Global *Service Bulletin*

BULLETIN NO: RT-138F-9/8
RT-138F FLEXCOMM VHF FM
Communications Transceiver

To maintain SCD and improve Digitally Coded Squelch (DCS) tone operation.

This modification consists of adding one capacitor and replacing one capacitor on the Encryption Compatible Board.

Figure 1
Encryption Compatible Board
300-2181 Rev-13

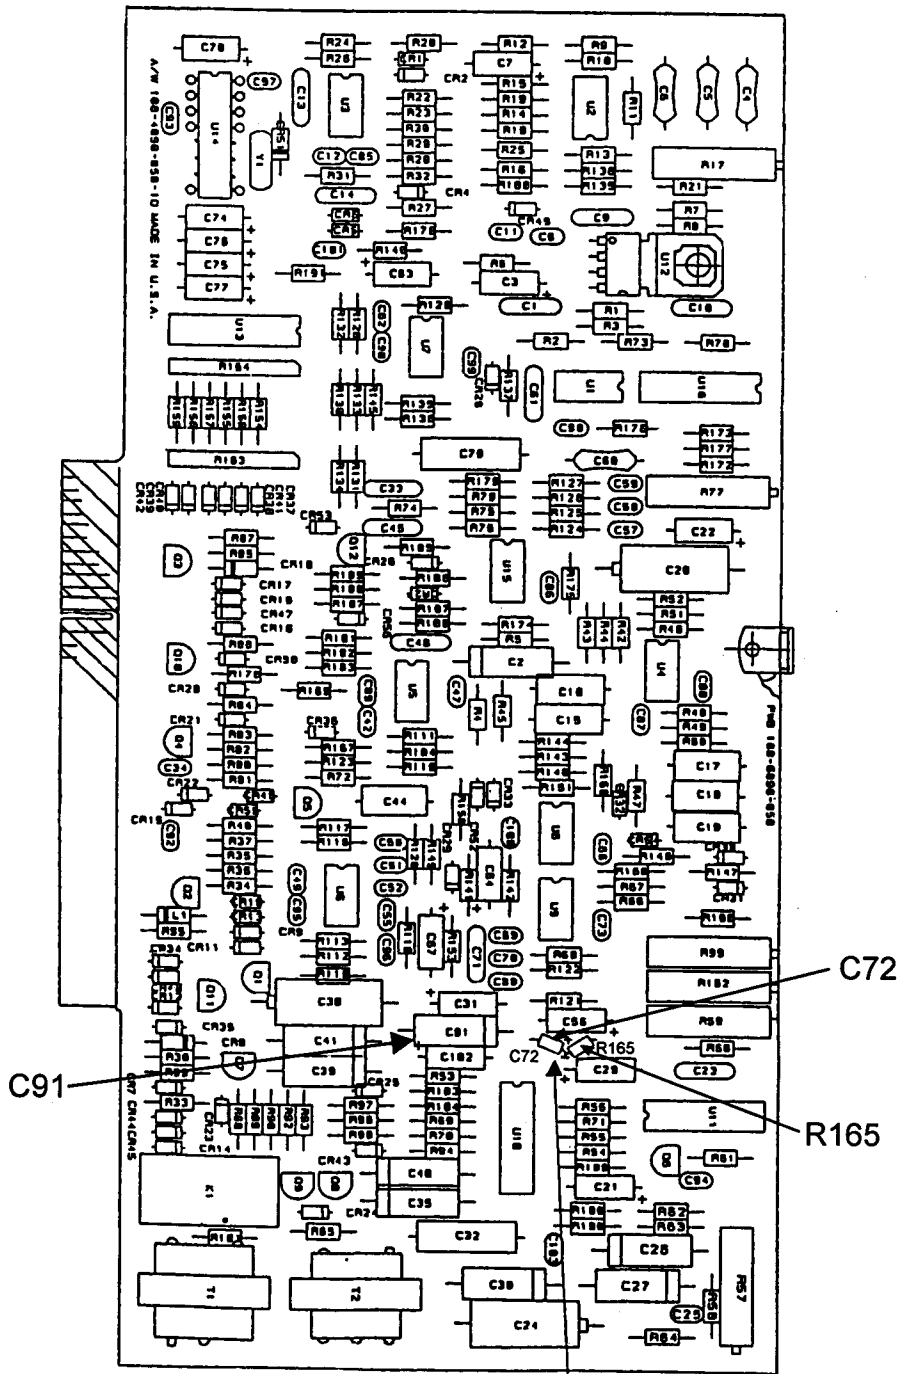
1. Access the Encryption Compatible Board according to the Disassembly Procedures in the Maintenance Manual.
2. See Figure 1. Lift the leg of R165 closest to C91. Install one leg of C72, P/N 096-01082-0064, into the pad where the leg of R165 was. Join and solder the raised legs of C72 and R165.
3. Replace C91 with a new C91, P/N 096-06396-0011.
4. Reassemble the unit.

REMOVE R165 LEG CLOSEST TO C91. INSTALL NEGATIVE LEG OF C72 INTO VIA HOLE LEFT BY LEG OF R165. ATTACH AND SOLDER REMAINING LEADS OF R165 AND C72 TOGETHER.
